## 03 Bay Elevations

Proposed Design - Milk Street

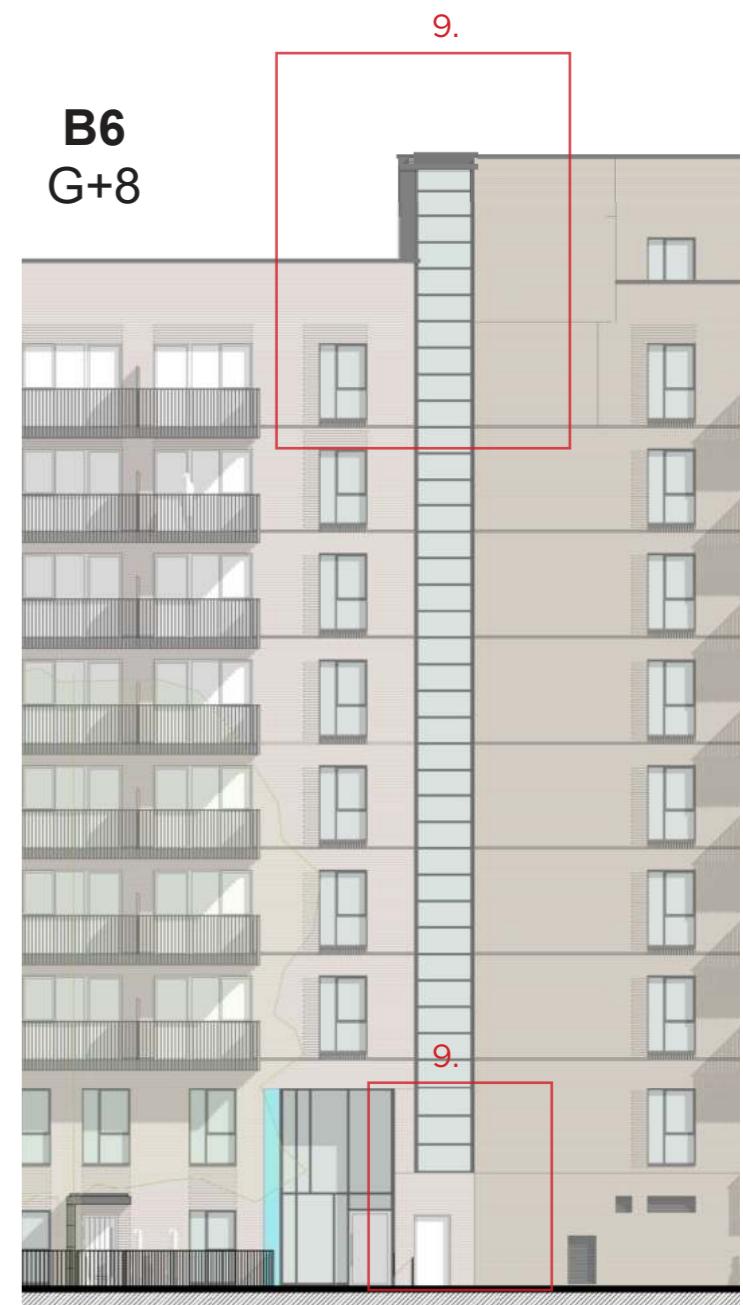
1. Rationalisation of balcony design as per previous phases
2. Windows omitted to suit developed stair/lift core design
3. Rationalisation of apartment stacking to facilitate drainage stacking / co-ordination
4. Window amended to ensure consistency between apartment type layouts
5. Window reduced to avoid internal clashes

6. Rationalisation / standardisation of balcony types
7. Balconies re-sized and linked to ensure compliance to London Plan area standards
8. Window type amended to match adjacent levels
9. Adjustment of architectural articulation
